Subject: Franklin Power Products, Inc./Amphenol Corporation
Request for Vapor Intrusion Investigation
Administrative Order on Consent, Docket # R8H-5-99-002
EPA ID# IND 044 587 848

Summary of Requested Work

FIGURE 1
 VI INVESTIGATION MAP

FORMER AMPHENOL RFI/CMS
 980 HURRICANE ROAD
 FRANKLIN, INDIANA

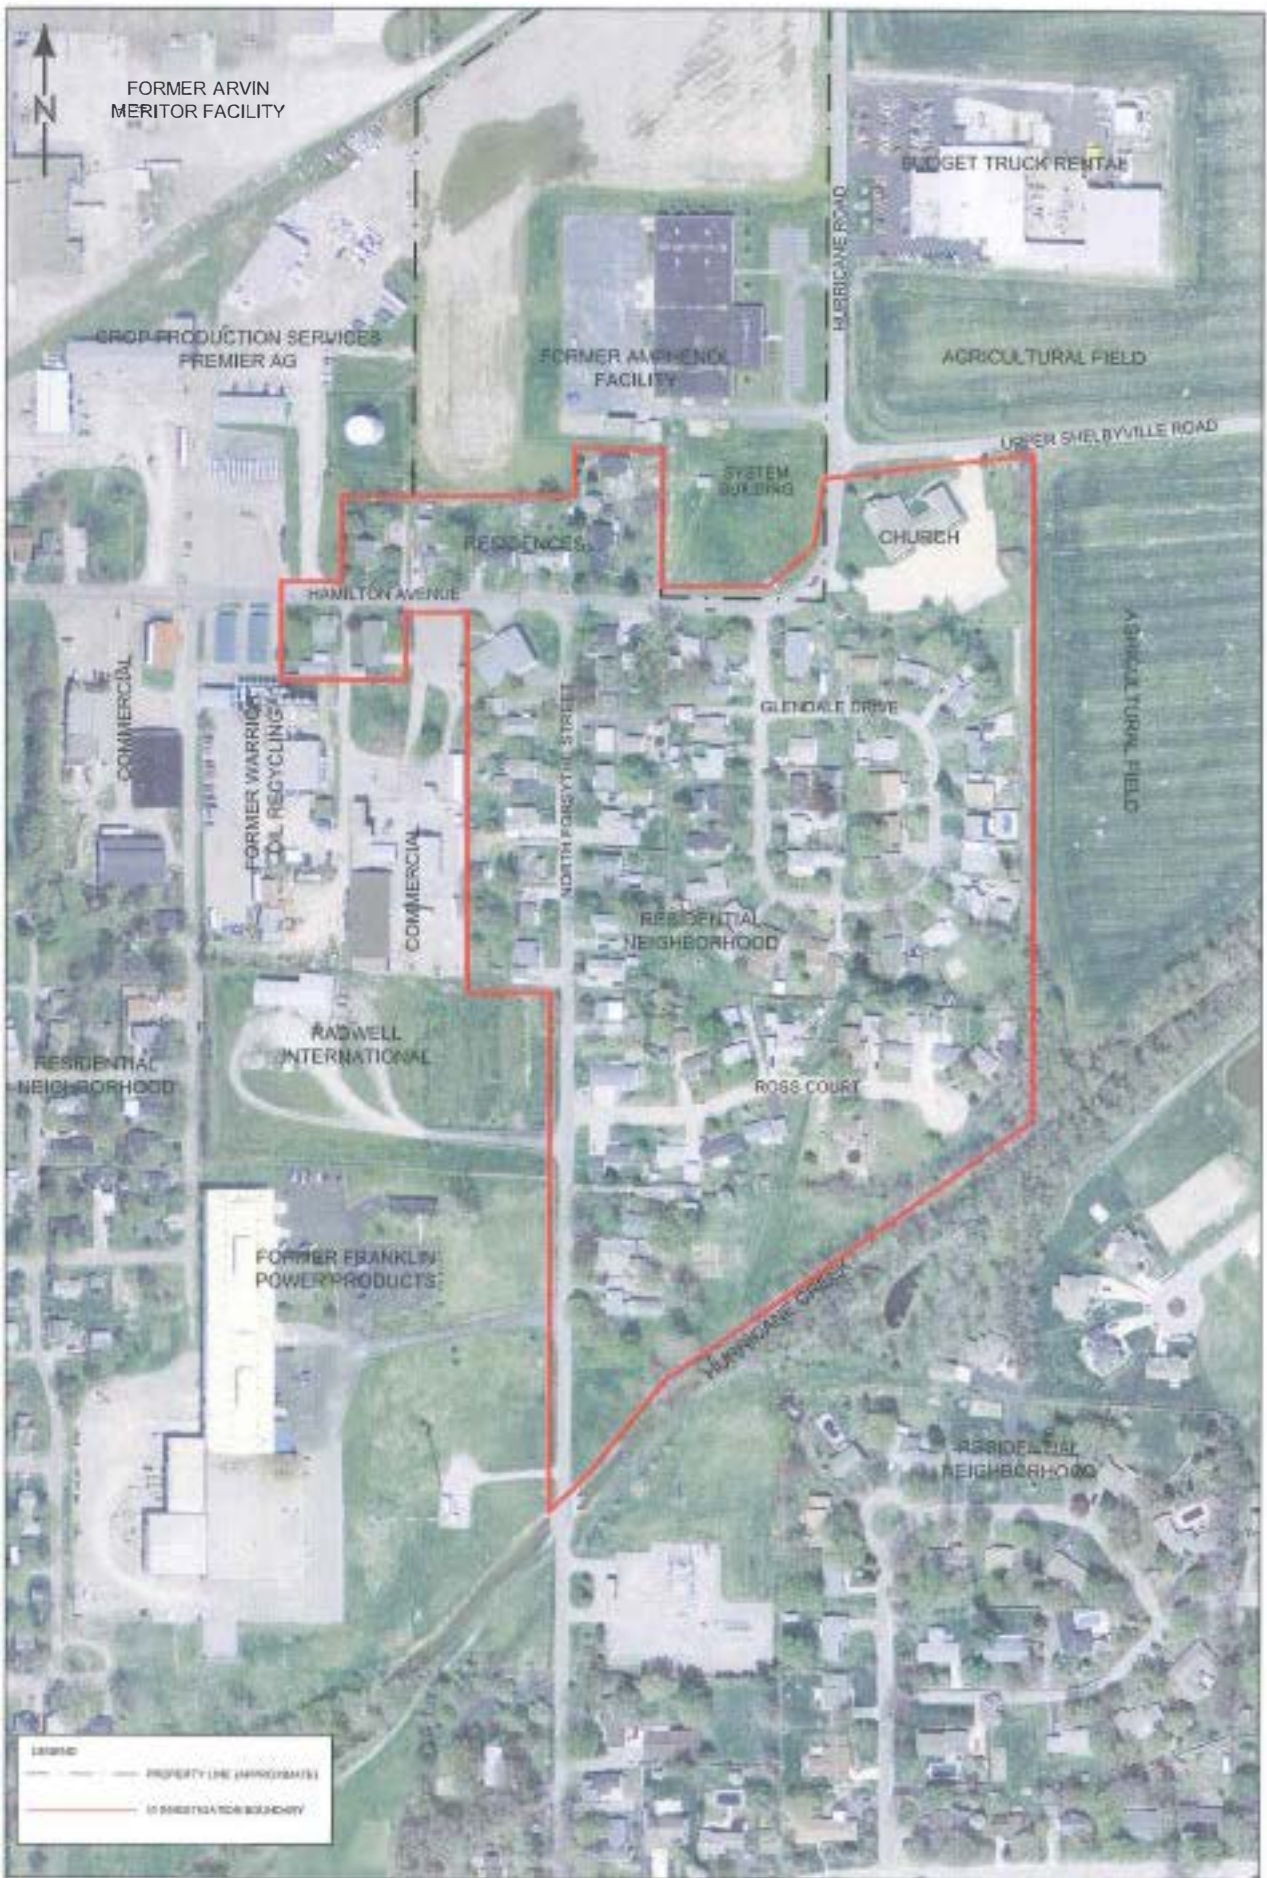
The Study Area includes portions of streets that are near and downgradient of the former facility: Hurricane Road, Hamilton Avenue, Forsythe Street, Glendale Drive, and Ross Court (figure provided by Amphenol Corp. enclosed).
